Addendum: Lower Yellowstone Intake Diversion Dam Fish Passage Project, Montana Draft Environmental Impact Statement

The Corps of Engineers (Corps) and the Bureau of Reclamation (Reclamation) have prepared this addendum to the Lower Yellowstone Intake Diversion Dam Fish Passage Project Draft Environmental Impact Statement (EIS) to provide the public with the opportunity to review and comment on the evaluation completed on scoping comments that were inadvertently overlooked during the preparation of the Draft EIS.

Figure 1 Hydraulic Ram Pump Schematic Layout

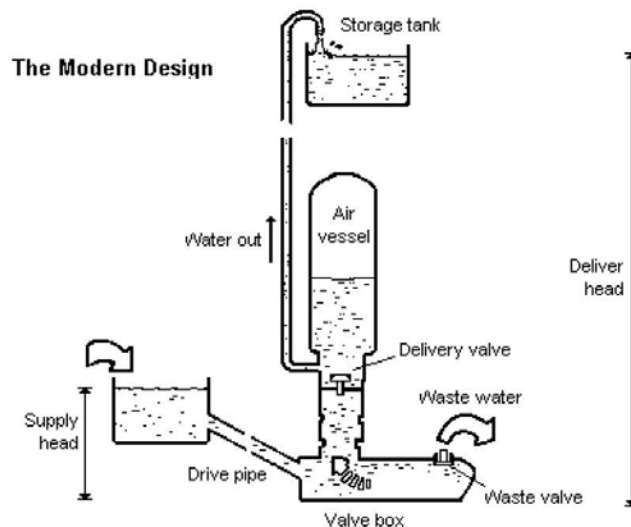
Hydraulic Ram Pumps- A commenter suggested that dam removal and pumping alternatives considered during scoping do not include reference to what the commenter considers the best practicable technology. It was recommended that hydraulic ram pumps requiring low hydraulic head pressure, no electrical supply, and minimal maintenance should be considered as an alternative pump technology.

A hydraulic ram pump does not require electrical energy to operate, however energy must still be provided to lift water up to the desired height (shown in Figure 1 as the Supply Head). The design references reflect this requirement by recommending that the stream have a minimum gradient of 2 percent (2 feet of fall in a 100 feet reach) and that a minimum of 6.6 feet of head be provided to the hydraulic ram pump (USDA, 2007).

The Yellowstone River has a gradient of approximately 2.0 – 2.5 feet per mile within the project area, or approximately 0.04 percent. This slope is approximately 50 times flatter than the 2 percent minimum recommended in the design guide, therefore hydraulic ram pumps do not appear to be a feasible solution to providing the necessary lift. The slope is important, because additional water to drive the ram would need to be diverted from the Yellowstone River along with the water being pumped into a feeder canal. The canal would have to be approximately three miles long to gain the minimum recommended head of 6.6 feet, which does not account for friction losses within the feeder canal.

As stated earlier, a maximum of 20 percent of the water diverted to the ram pump can actually be lifted and the rest would overflow back to the Yellowstone River. Therefore, to deliver 50 cfs to the canal by a hydraulic ram would require diverting 250 cfs from the Yellowstone with the other 200 cfs being overflow. Note that we have not identified applications of ram pumps with this capacity, all are over an order of magnitude smaller.

Therefore, considering the lack of necessary head in the project area, low efficiencies of the pumps, and the need to divert almost the entire Yellowstone River during low summer flows to get the required 1,374 cfs, this alternative will not be carried forward for further analysis.
